**From:** Rochlin, Kevin  
**Sent:** Friday, February 14, 2014 12:13 PM  
**To:** Douglas.Tanner; Greutert, Ed [USA]; Kelly Wright; Scott Miller; Stifelman, Marc; susanh@ida.net; Zavala, Bernie  
**Cc:** Rochlin, Kevin  
**Subject:** FW: Comments on the Gamma Study Report  
**Attachments:** RESRAD-FMC Gamma Caprev2.docx; Resrad plotrev3.xlsx

### RESRAD Calculation: Ratio of Dose Rate to Dose Rate with 12 Inch Cap

## RESRAD Analyses of Gamma Caps for FMC Slag

### Ratio of Dose Rate to Dose Rate with 12 inch Cap

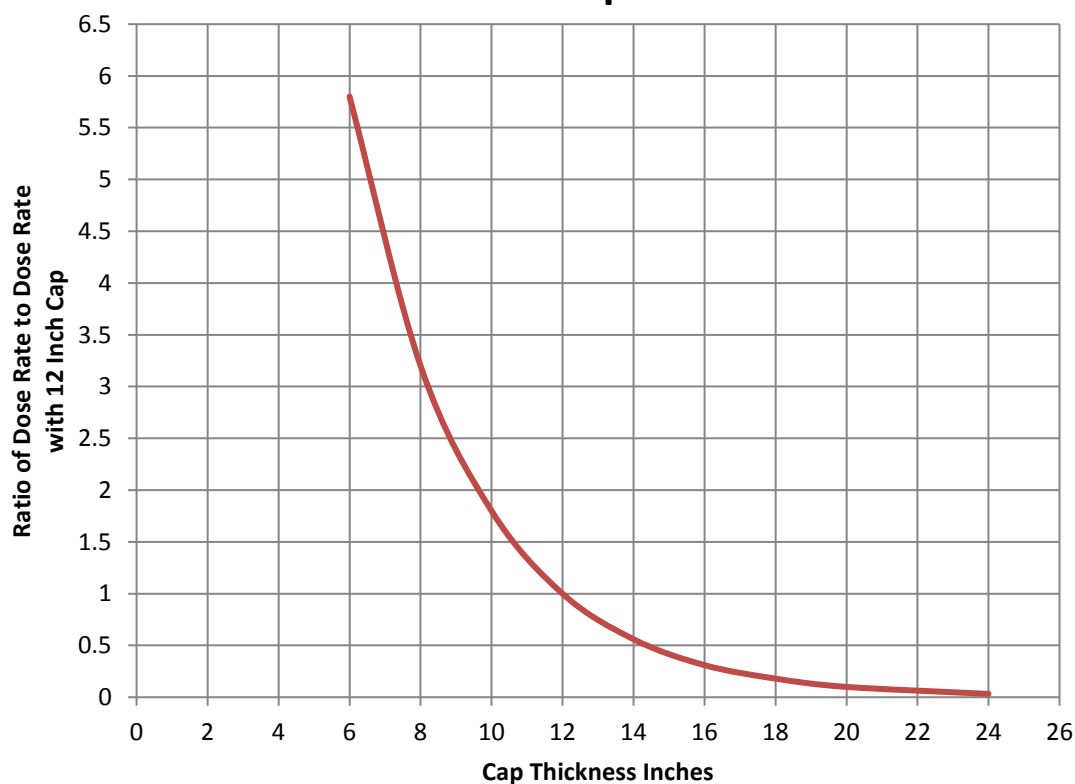
To evaluate the effectiveness of various thicknesses of cap cover, a series of RESRAD calculations were performed assuming various thickness of cap. Results were normalized to radiation levels obtained with a 12 inch cap using RESRAD. For example, a 6 inch cap is estimated to have a residual radiation level 5.8 times higher than a 12 inch cap. From these results it can be seen that RESRAD calculates that a 12 inch cap would reduce radiation levels to 1.3 uR/hr. This is less than half of the 2.8 uR/hr risk-based criterion for cap performance. On this basis, residual radiation levels could still be acceptable even if Ra-226 concentration levels in slag were twice the assumed average levels. The same data also indicates that a cap thickness of 10 inches could be sufficient to meet a 2.8 uR/hr criterion. These conclusions are consistent with the observation that a cap thickness of 12 inches appears to be a conservative value based on RESRAD calculation.

A plot of the RESRAD results also shows that the reduction in radiation level with increasing cap thickness is not linear. There is an inflection point in the neighborhood of 12 inch cap thickness after which there are diminishing returns indicated for additional thickness of cap. In terms of “bang for the buck”, a cap thickness of 12 inches therefore appears to be a cost-effective and practical value.
